CITY OF BEAUFORT HISTORIC DISTRICT REVIEW BOARD PROJECT APPLICATION (Revised - 09/24/2014)

Application #: HR15-17 Date Received: 5-26-15 Zoning District: GR  
Beaufort County 1997 Historic Survey Listing: U-13-1344

**CITY OF BEAUFORT**  
**Historic District Review Board**  
**Full Board**  
**Staff Report**  
**Meeting of July 8, 2015**

**Case Number:** HR 15-17  
**Property Address:** 1310 Washington Street  
**Applicant:** Elijah Seabrook, Jr.  
**Type of Request:** Demolition (Final Review)  
**Zoning:** GR – General Residential

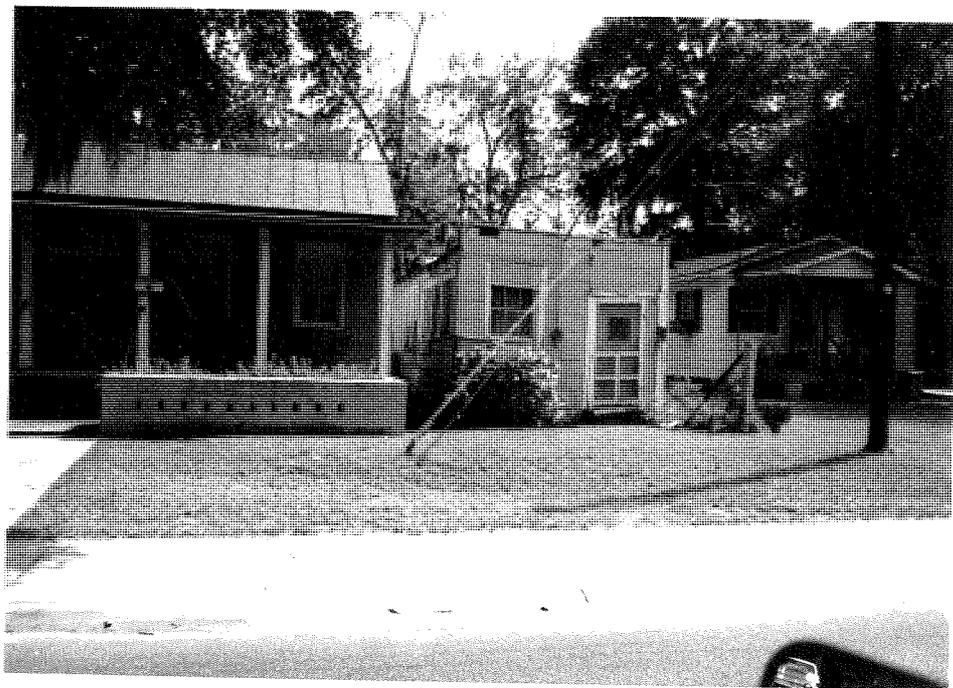
**Historical:** 1310 Washington Street is located in the Historic District. It is listed as contributing in the *Beaufort County Historic Sites Survey*, circa 1910. However it does not appear on the 1912 Sanborn map. It first appears on the 1924 map and is shown in the same configuration on the 1958 map (right). Since 1958 it has undergone alterations including asbestos siding and a rear addition. In more recent history the front porch has been removed due to collapse.

- This cottage is listed as contributing due to its age and configuration as a traditional freedman’s cottage house type.
- It is not unique in its architecture but rather one of a number of this typology in this area.
- While it is unfortunate to lose a piece of history, this structure is having a negative contribution on the rest of the block and neighborhood. The three adjacent parcels to the east are vacant and will likely remain that way with a dilapidated structure next door.

**Staff Recommendation: Final approval as submitted.**
